APPLICATION NO.	FILING DATE	FIRST NAMED INVENTOR	ATTORNEY DOCKET NO.	CONFIRMATION NO.
10/595,283	04/10/2006	Bocang QIU	305832-00124	6702
64770 7590 09/04/2007 MOMKUS MCCLUSKEY MONROE MARSH & SPYRATOS, LLC 3051 OAK GROVE ROAD SUITE 220 DOWNERS GROVE, IL 60515-1181			EXAMINER ROJAS, OMAR R	
			ART UNIT 2874	PAPER NUMBER
			MAIL DATE 09/04/2007	DELIVERY MODE PAPER

Office Action Summary

DETAILED ACTION

FIG. 1

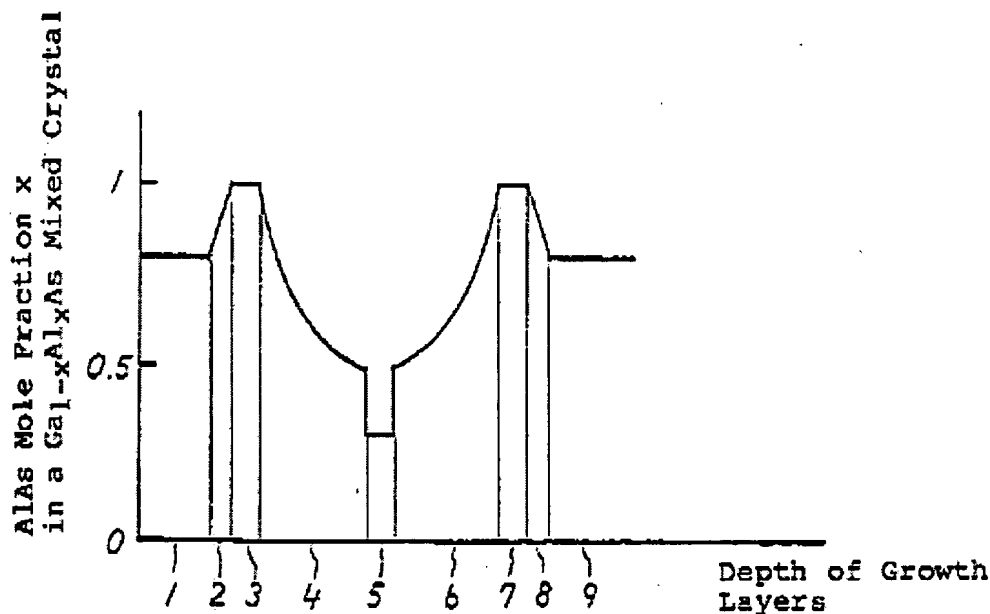
In re claim 1, Hayakawa discloses a semiconductor optical waveguiding device comprising:

a first cladding layer 1/2/3/4;

a second cladding layer 6/7/8/9; and

a waveguiding layer 5 disposed between the first and second cladding layers and having a substantially higher refractive index than said first and second cladding layers;

wherein at least one of the first and second cladding layers includes a beam control layer 2/4/6/8 in which a property of the semiconductor material varies as a function of depth through the layer, the beam control layer including a first sub-layer 2/8 in which the property varies gradually from a first level to a second level, and a second sub-layer 4/6 in which the property varies gradually from said second level to a third level. Figure 1 of Hayakawa is reproduced below.

FIG. 7

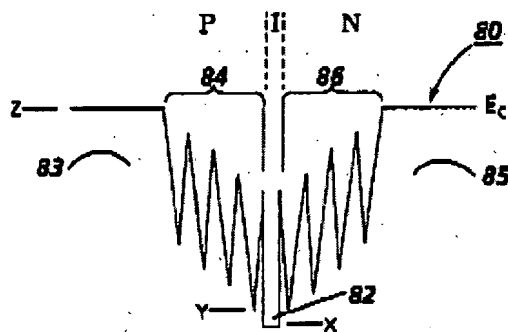
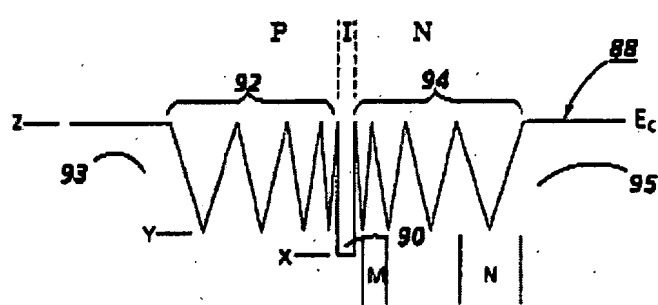
In re claim 1, Scifres discloses a semiconductor optical waveguiding device 80/88 comprising:

a first cladding layer 85/86 or 94/95 ;

a second cladding layer 83/84 or 92/93; and

a waveguiding layer 82 or 90 disposed between the first and second cladding layers and having a substantially higher refractive index than said first and second cladding layers;

wherein at least one of the first and second cladding layers includes a beam control layer 84/86 or 92/94 in which a property of the semiconductor material varies as a function of depth through the layer, the beam control layer including a first sub-layer in which the property varies gradually from a first level to a second level, and a second sub-layer in which the property varies gradually from said second level to a third level. Figures 7 and 8 of Scifres are reproduced below.
